# UNITED STATES PATENT AND TRADEMARK OFFICE

APPLICATION NO.	FILING DATE	FIRST NAMED INVENTOR	ATTORNEY DOCKET NO.	CONFIRMATION NO.
10/725,732	12/02/2003	Tobias Siencel	60,246-258/10781	3046
26096 7590 09/10/2007 CARLSON, GASKEY & OLDS, P.C. 400 WEST MAPLE ROAD SUITE 350 BIRMINGHAM, MI 48009			EXAMINER CIRIC, LJILJANA V	
			ART UNIT 3744	PAPER NUMBER
			MAIL DATE 09/10/2007	DELIVERY MODE PAPER

**FREEZE PROTECTION FOR HEAT PUMP SYSTEM**  
Applicant: Sienel; Serial No. 10/725,732  
REPLACEMENT DRAWINGS

**FIG.2**

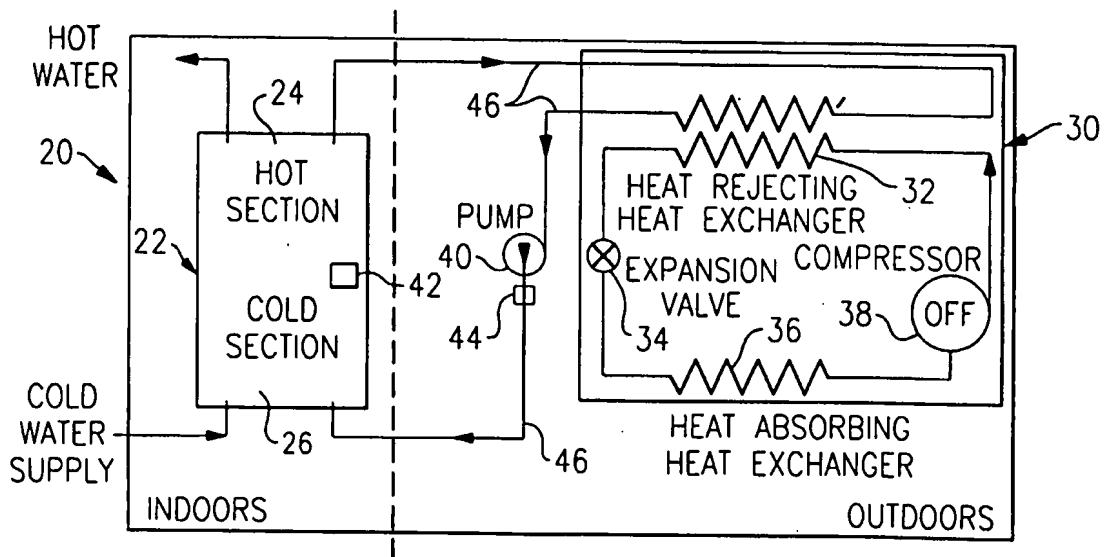
4. The replacement drawings were received on January 8, 2007. These replacement drawings are NOT approved because, in addition to various objections explained in greater detail below, the replacement drawings contain new matter. In particular, Figure 2 of the replacement drawings shows refrigerant as flowing through the heat pump refrigerant circuit when compressor 38 is OFF; this constitutes new matter because, for example, the originally filed drawings (i.e., the drawings filed on December 2, 2003) do not show any refrigerant flow through the refrigerant circuit of the heat pump when compressor 38 is OFF.

5. The drawings filed on January 8, 2007 are also objected to under 37 CFR 1.83(a). The drawings must show every feature of the invention specified in the claims. Therefore, the following features must be shown or the features canceled from the claims: a control for the pump as newly recited in claims 1 through 5 and 10 through 14; and, a temperature sensor which senses an ambient outdoor temperature as newly recited in claims 13 and 14. No new matter should be entered.

*Not approved.*  
*AVC*  
*8-31-07*

Corrected drawing sheets in compliance with 37 CFR 1.121(d) are required in reply to the Office action to avoid abandonment of the application. Any amended replacement drawing sheet should include all of the figures appearing on the immediate prior version of the sheet, even if only one figure is being
